Nepal Electricity Authority
Project Management Directorate
Khimti-Barhabise-Lapsipedi 400 kV Substation Project

OCB No.: PMD/PTDSSP/KBL-75/76-01" Design, Supply, Installation and Commissioning of 400 kV Gas Insulated Substations (GIS) at New Khimti, Barhabise and Lapsipedi"

Clarification No. 1					
S.N.	Vol/Sec	Clause	Text as per Bid document	Bidder's Queries	NEA Response
1	Vol-I, Section-1	ITB 35.2 and BDS	ITB -The determination shall be based upon an examination of the documentary evidence of the Bidder's qualifications submitted by the Bidder, pursuant to ITB 15. Unless permitted in the BDS, the determination shall not take into consideration the qualifications of other firms such as the Bidder's subsidiaries, parent entities, affiliates, subcontractors (other than Specialist Subcontractors if permitted in the bidding document), or any other firm(s) different from the Bidder. BDS- The qualifications of other firms such as the Bidder's subsidiaries, parent entities, affiliates, subcontractors shall not be permitted.	In case of the carve out ,merger, demerger of companies and a new entity formed due to the same, can you please clarify as to what financial and technical qualifica

DRAWING NO.: BARHABISE-GIS-LAYOUT-2(B)

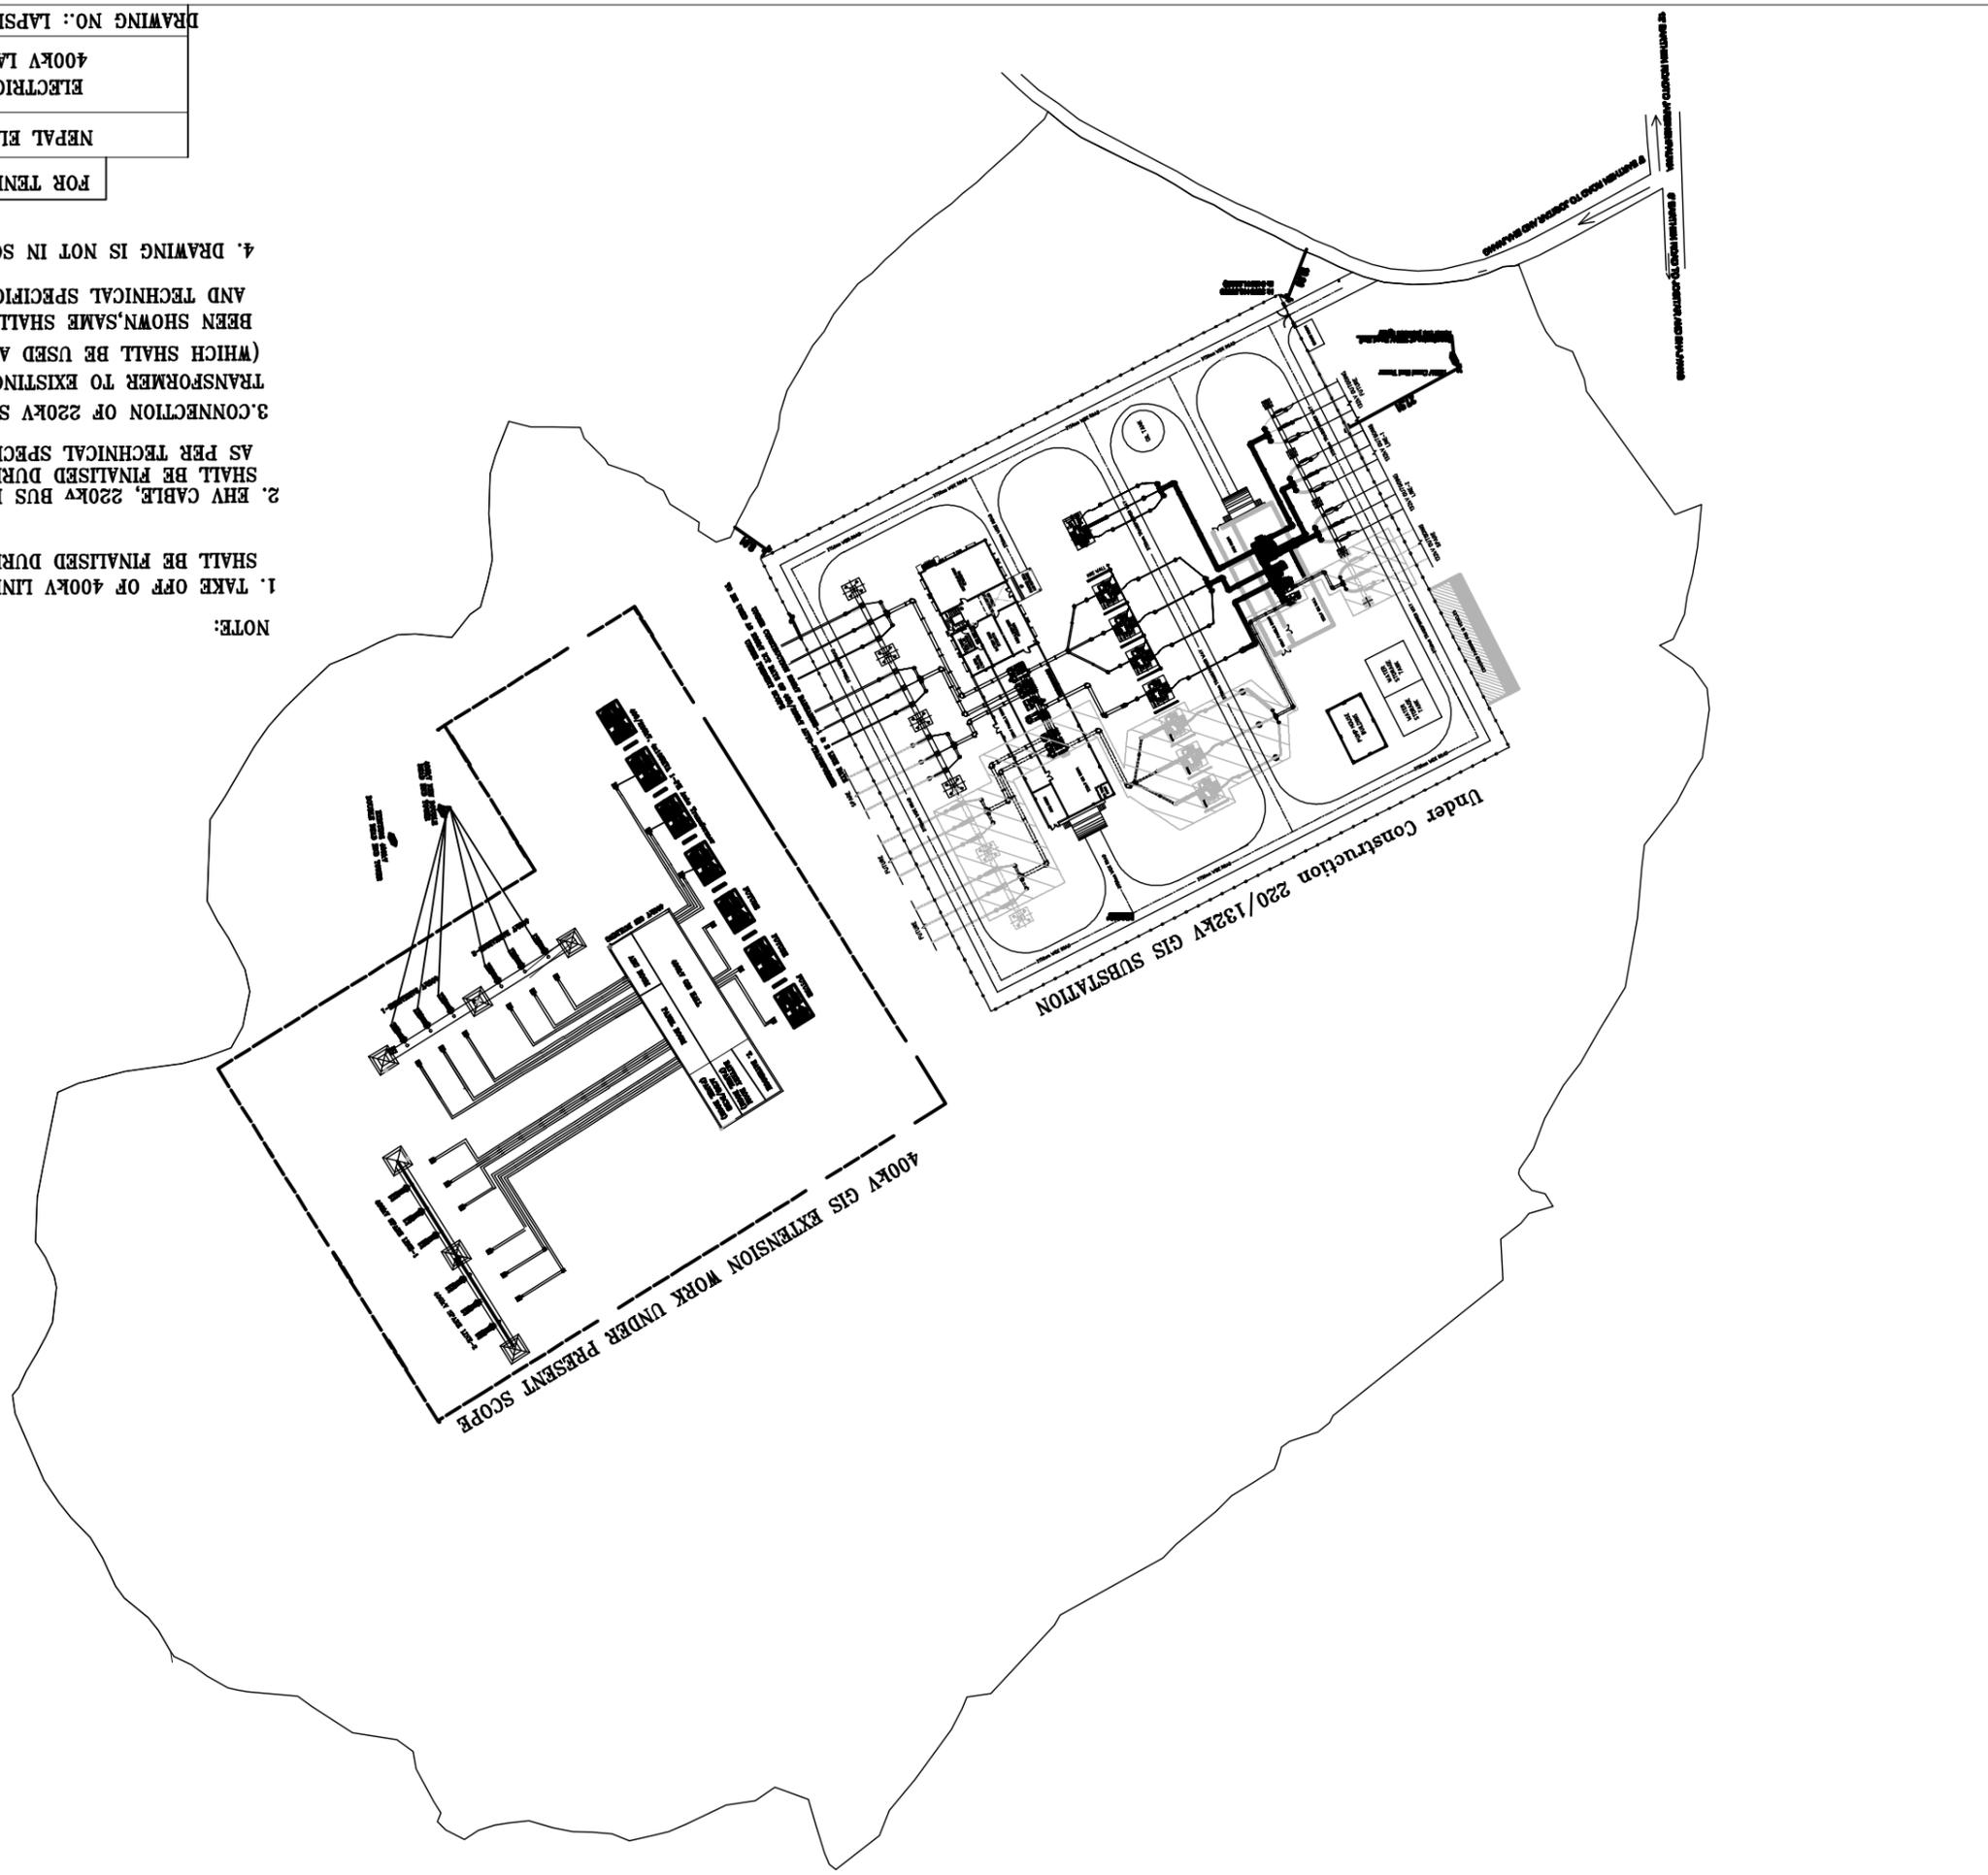
28	Barhabise Substation	Drawings and Bid Price Schedule	Electrical Layout plan of Barhabise Substation		It is observed from Electrical Layout Plan (Drawing no. BARHABISE/GIS/LAYOUT/2(A)) that the existing 220kV bus duct is being constructed by other contractor upto 220kV Line Gantry. Please confirm that this bus duct can be utilized by the 400kV GIS contractor for connection between 400/220kV ICT and the concerned 220kV Line bay (which will be converted to ICT bay).	Bidders understanding is generally in order.
29	Lapsipedi Substation	Drawings and Bid Price Schedule	Electrical Layout plan of Lapsipedi Substation		From Electrical Layout Plan drawing, it is observed that three phase bus duct is considered in the existing 220kV line bay upto the 220kV gantry. Please confirm that this bus duct can be utilized by the 400kV GIS contractor for connection between 400/220kV ICT and the concerned 220kV Line bay. However, since 220kV gas insulated bus duct should be of single phase type as per Technical specification and BOQ of this project, Kindly confirm that 3 phase type 220kV GIB may still be used.	Bidders understanding is generally in order. Regarding 3-phase or 1-phase bus duct, bidder is to quote as per BPS.

DRAWING NO.: LAPSIPHEDEI-GIS-LAYOUT-01

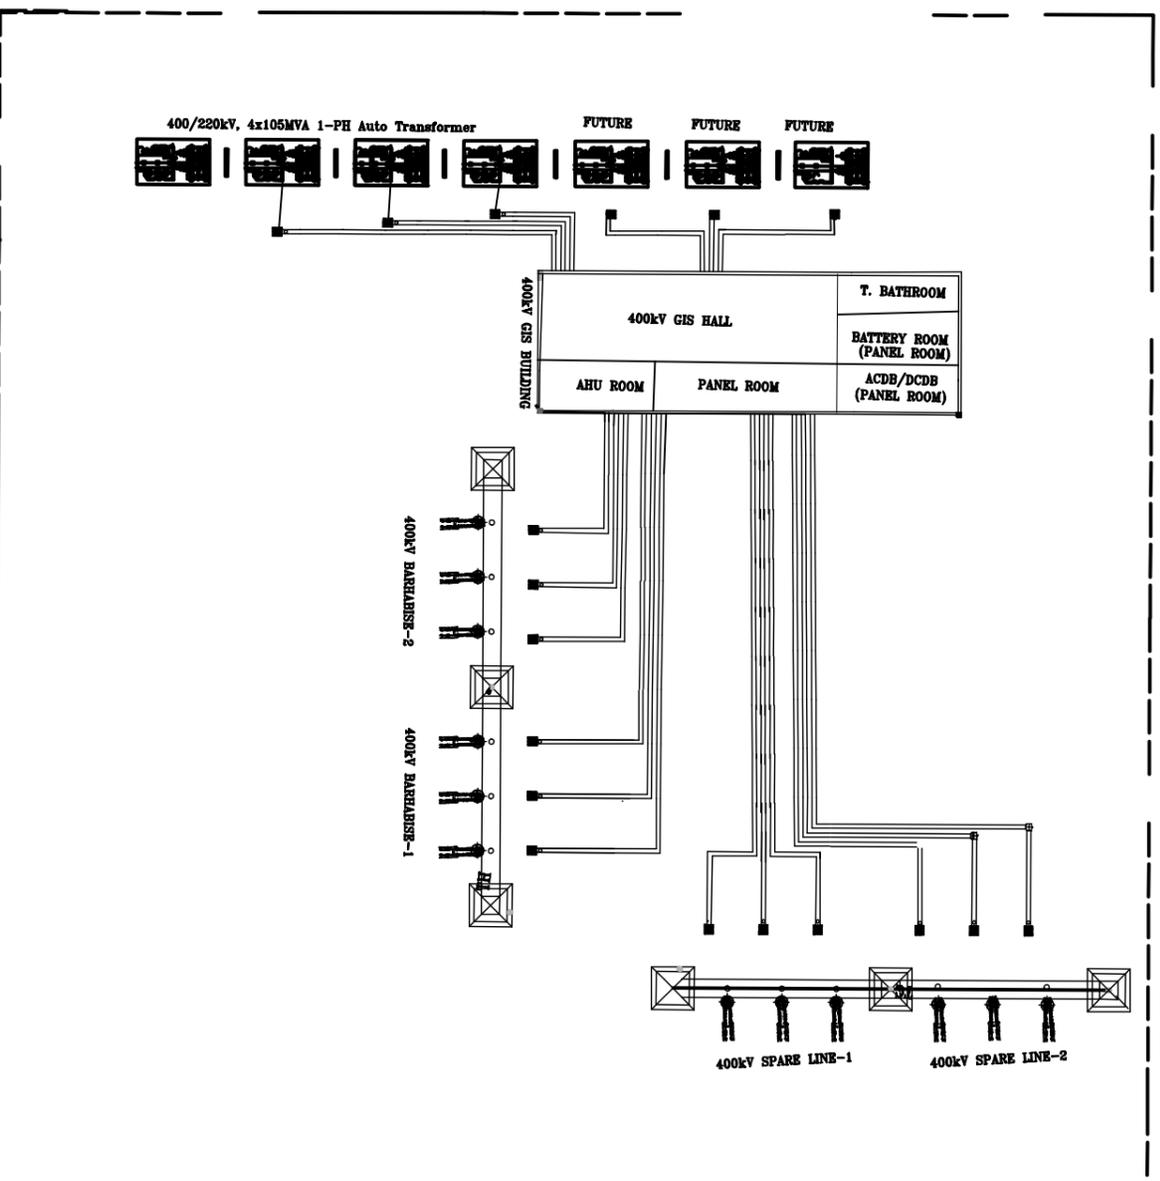
29	Lepsipdehi	1558513179_Drawings		400kV GIS Lepsipedhi substation Dwg. No. LEPSIPEDHI-LAYOUT-02(A)	The connectivity of 220kV Switchyard from the ICT is not clear from the layout. Please provide a revised layout for the same.	220 kV GIS line bays with 220 kV Bus duct upto 220kV Line Gantry is under construction by 220 kV Substation Project. Connection of 220 kV Cables from LV side of 400/220 kV Transformer upto above under construction 220kV Bus duct nearby 220kV line Gantry is under present scope.220 kV GIS termination shall be outdoor.
30	Lepsipdehi	1558513179_Drawings		H. Erection Hardware H.2 220kV DM-type layout for GIS termination arrangement of Transformer.	Please provide a legible layout showing the GIB connection from the Transformer to the respective 220kV bay. 	220 kV GIS line bays with 220 kV Bus duct upto 220kV Line Gantry is under construction by 220 kV Substation Project. Connection of 220 kV Cables from LV side of 400/220 kV Transformer upto above under construction 220kV Bus duct nearby 220kV line Gantry is under present scope.220 kV GIS termination shall be outdoor.
